# **STRUCTURE FOUNDATION EXPLORATION- FINAL REPORT**

**HIG-247-0.04, PID NO. 93830  
BRIDGE NUMBER: 3603482  
HIGHLAND COUNTY, OHIO  
CTL PROJECT NO. 22050095COL**

Reference: Response to Stage 2 Comments  
HIG-247-0.04, PID No. 93830  
Bridge Number: 3603482  
Highland County, Ohio  
CTL Project No. 22050095COL

GEOTECHNICAL PROFILE - BRIDGE  
 BRIDGE NO. HIG-247-0.04 - S.R. 247 OVER BUCK RUN

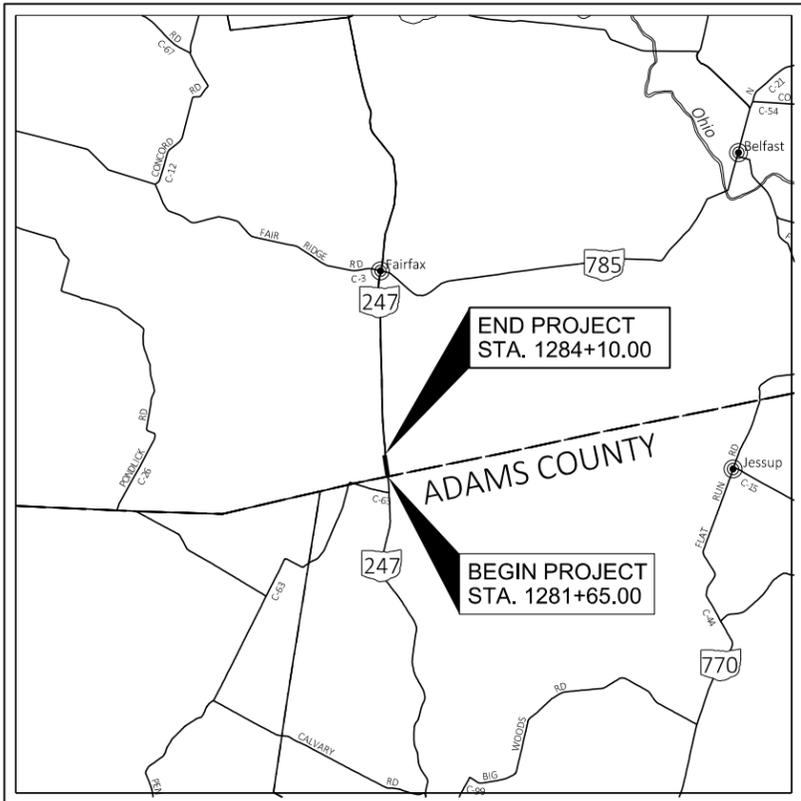
- b. Sheet 1/7 – revise the historic records section to say “No historic records were found for this structure. However, the historic roadway borings (TIMS sub-batch 9666) indicate that the top of rock was encountered between El. 905 and 910 feet and limestone was exposed in the creek bed.” In the second paragraph under “Exploration Findings,” change “911” to “911.4” in the third line. Also change the last sentence to “... samples were described as predominantly limestone with a minor amount of shale.” In the heading of the scour analysis table, use two lower case m’s to represent millimeters. Two capital M’s can be interpreted to mean millions.

**Response:** Sheet 1/7 has been updated per the comment.

GEOTECHNICAL PROFILE - BRIDGE  
 BRIDGE NO. - HIG-247-0.04  
 S.R. 247 OVER BUCK RUN

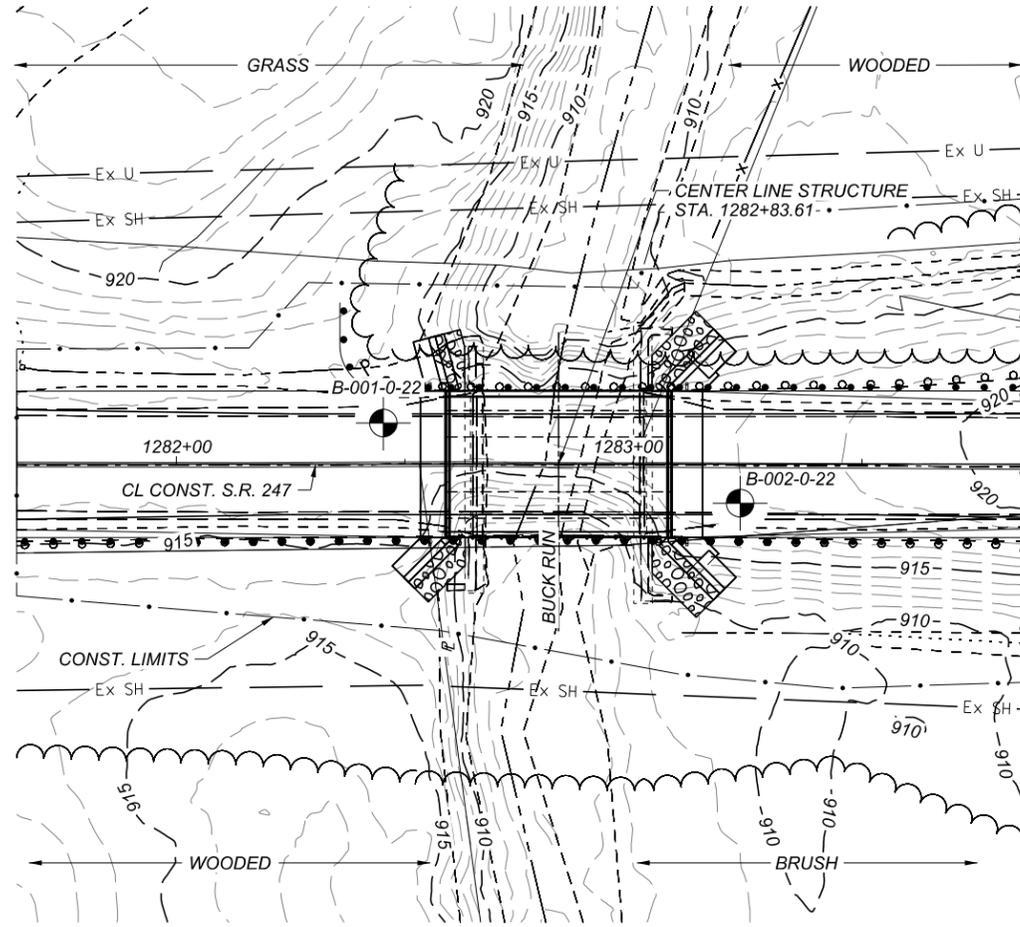
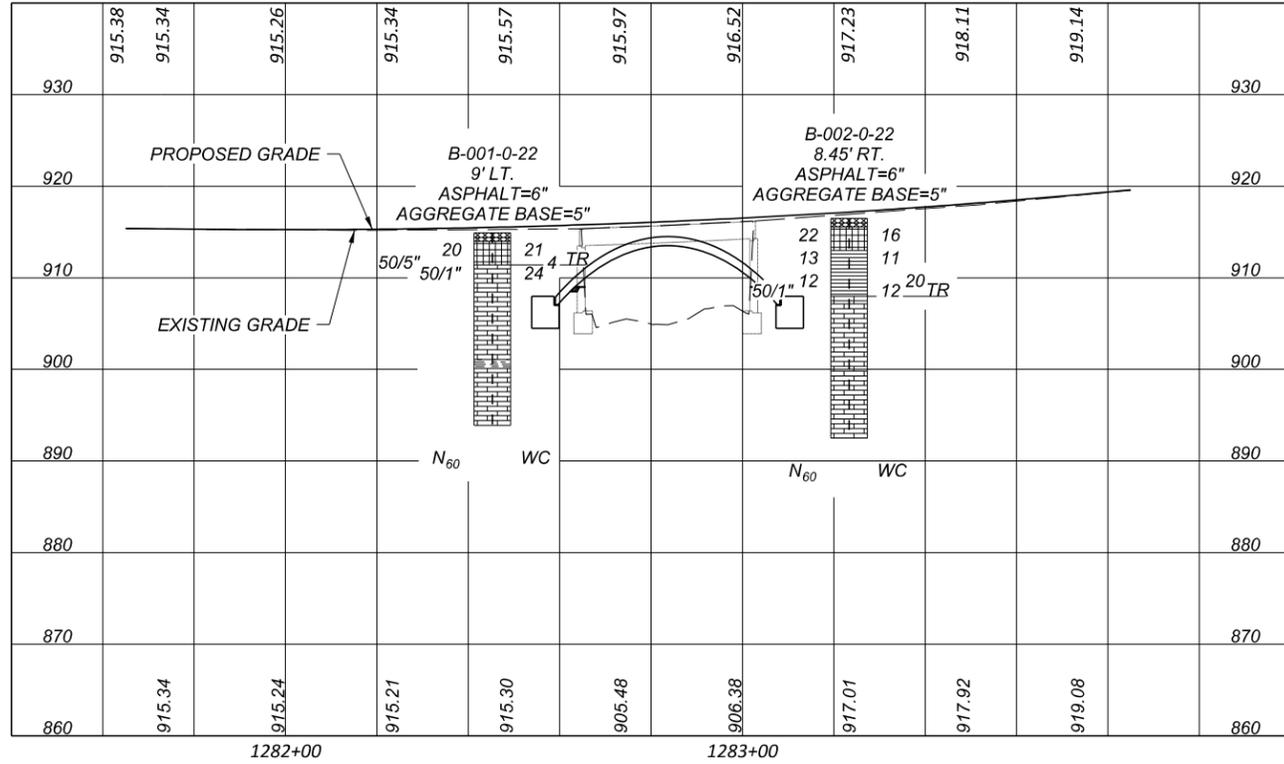
- c. Sheet 2/7, Plan and Profile – show existing land usage descriptions in the plan view, in accordance with SGE Section 702.5.1. The callouts regarding the MGS guardrail and

**Response:** Sheet 2/7 has been updated per the comment.
